October 15, 2021

Re: Conservation Organizations Comments on North Carolina's Proposed Regional Haze State Implementation Plan (SIP) for North Carolina Class I Areas for the Second Planning Period (2019 - 2028)

Figure 1: IMPROVE Visibility Reconstructed Extinction by Month (2016-18)
Shenandoah National Park VA (SHEN): 20% Most Impaired Days
From Gebhart 2020

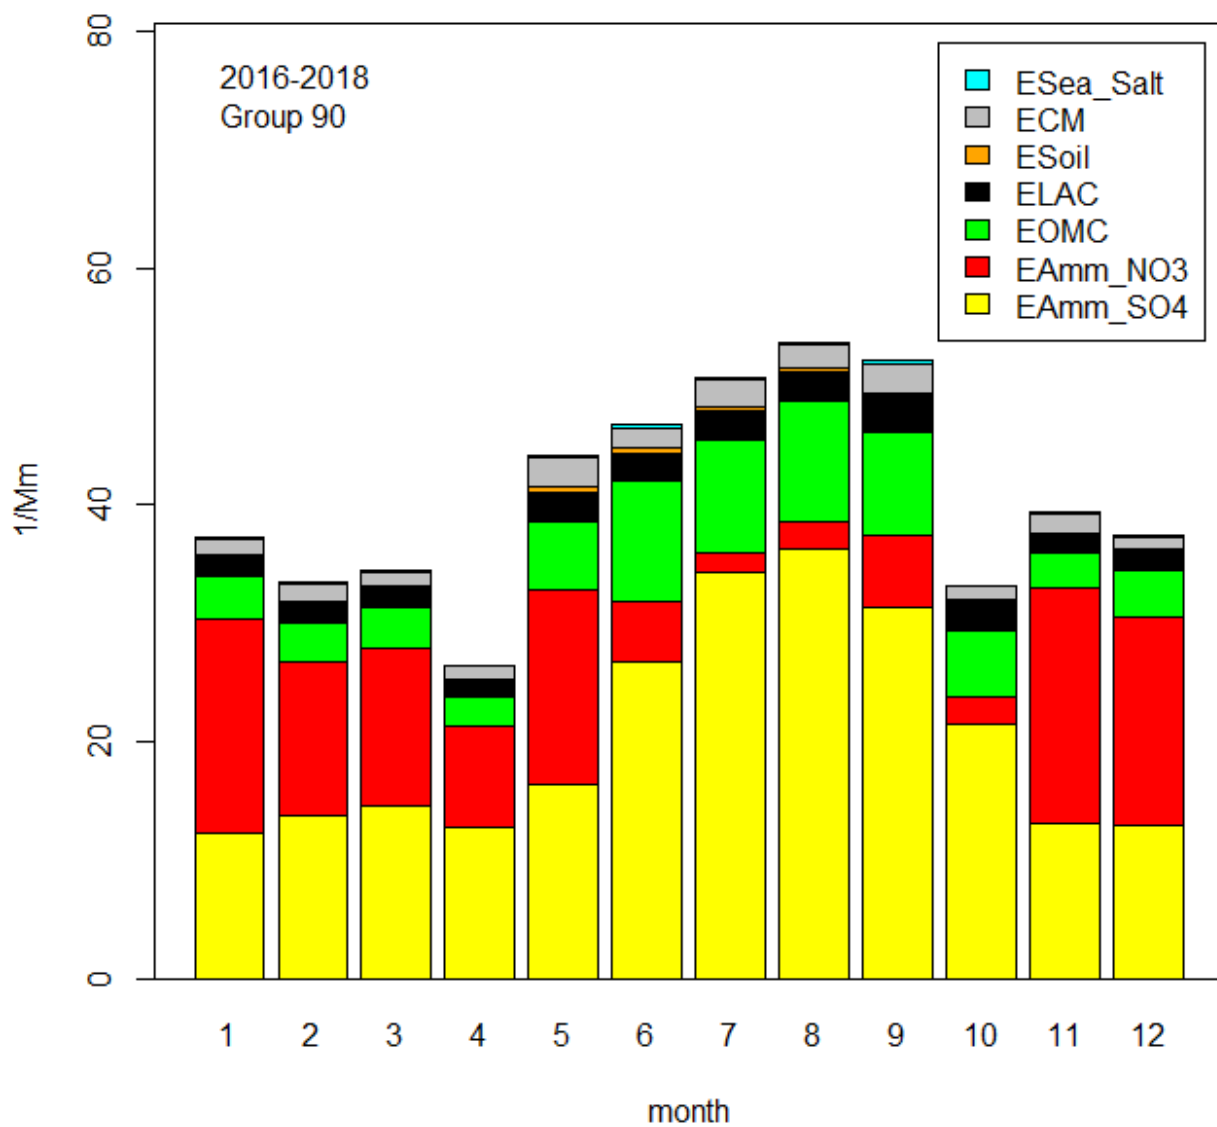
The negative sulfate bias occurred across all seasons but was larger during the summer months. This bias was also present across the entirety of the VISTAS modeling domain. For those Class I areas in the VISTAS domain, the occurrence of the 20% most impaired days was more frequent during the summertime and sulfate was also a major contributor to visibility impairment in the summer months. As an example, Figure 1 presents a monthly distribution for IMPROVE visibility data collected at Shenandoah National Park (SHEN) for the 20% most impaired visibility days (2016-18). Figure 1 shows that reconstructed extinction (a measure of impaired visibility) is largest at SHEN in the summer and that sulfate is the largest contributor to the measured summertime visibility impairment.

While no air quality model is perfect, the large and significant sulfate underprediction calls into question how one should best apply the VISTAS II CAMx model results. As Figure 1 demonstrates, the modeling errors are largest for the same period when the sulfate concentrations make the largest contribution to visibility impairment. The large sulfate underprediction means that the VISTAS II CAMx results should not be used directly without properly accounting for the known sulfate bias. The known sulfate underprediction in the VISTAS II CAMx modeling results also has repercussions in other areas. These issues are addressed in other sections of my report.

Figure 2
Temporal Trends in Reconstructed Extinction
Great Smoky Mountains National Park⁷

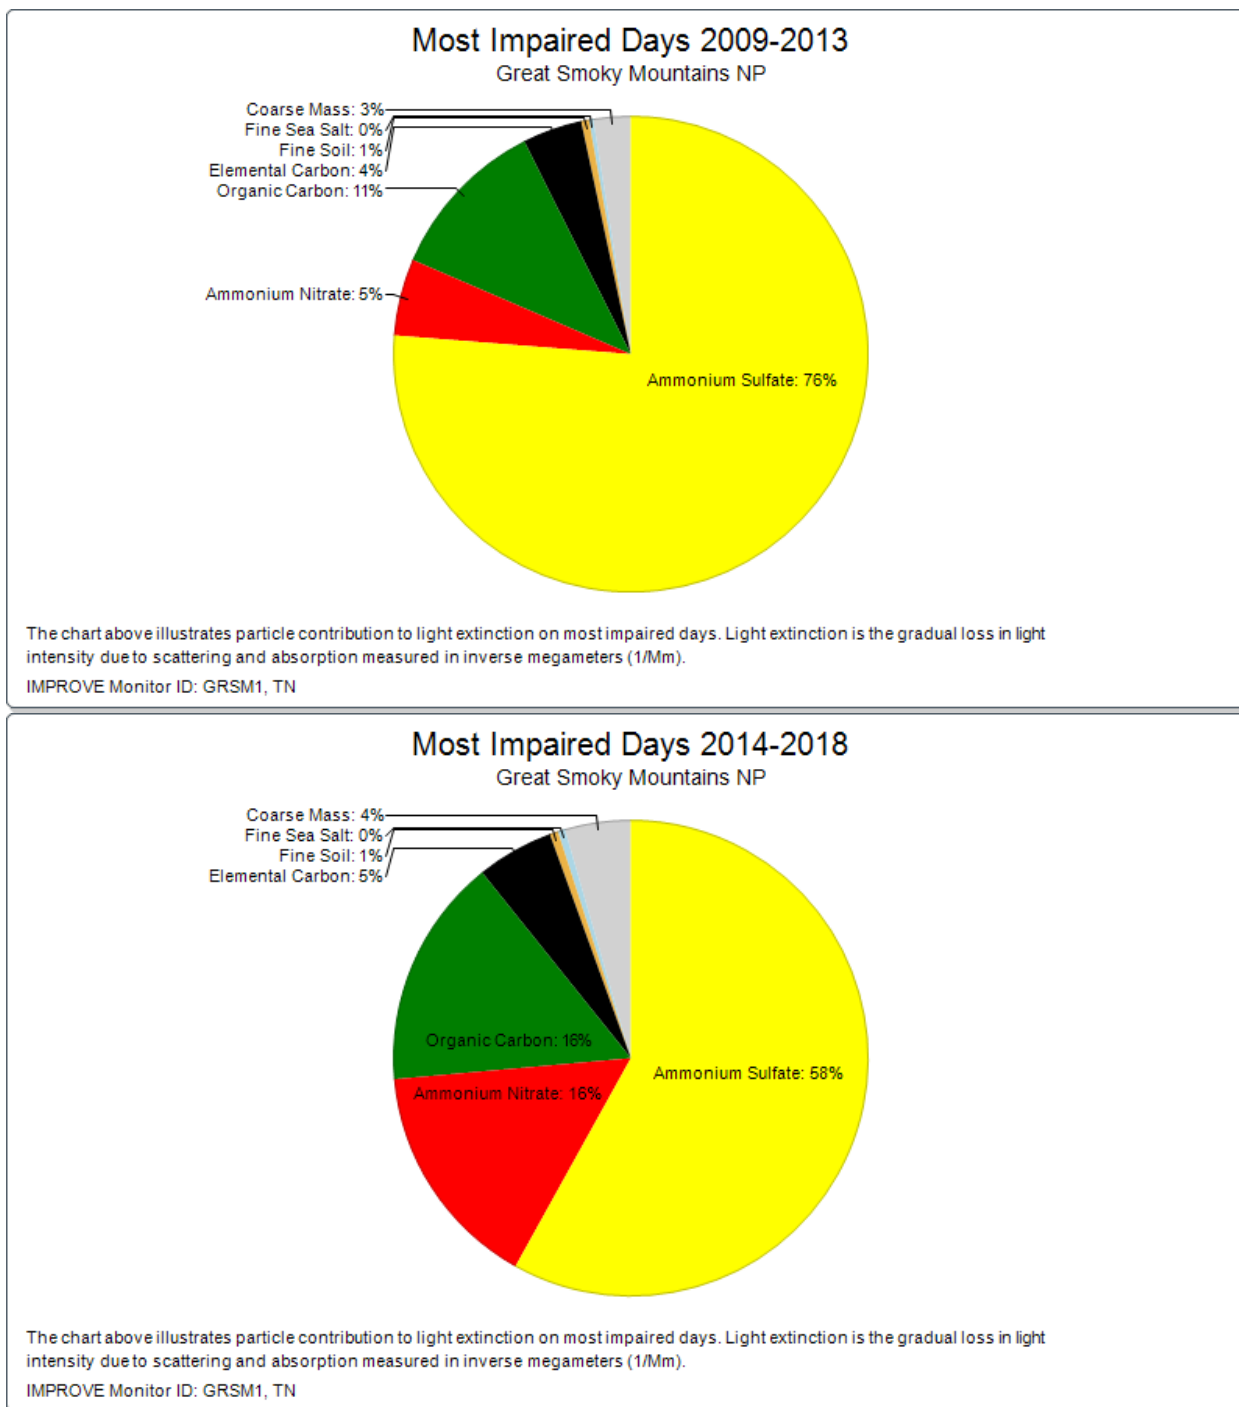
As an example which illustrates the changes described above, Figure 2 presents the reconstructed extinction for the 20% most-impaired days at Great Smoky Mountains National Park (GRSM). The data in Figure 2 compare the reconstructed extinction for the 20% most-impaired days covering the 2009-13 baseline period against the 2014-18 period. The 2014-18 time period would have been the most recent IMPROVE data available at the of the VISTAS II modeling effort.

The reconstructed extinction on the 20% most-impaired days in Figure 2 shows a dramatic trend toward less sulfate extinction and greater nitrate extinction. The decrease in sulfate likely represents the effect of SO₂ emission controls and other regulatory actions including those that were imposed in the first round of regional haze SIPs. In turn, nitrate has become an increasingly important contributor to current visibility impairment. For example, at GRSM, the nitrate extinction budget has roughly tripled since the 2009-13 baseline period, increasing from 5 percent to 16 percent. The temporal trends showing increased nitrate extinction for the 20% most-impaired days are also repeated at other Class I areas in the VISTAS domain.
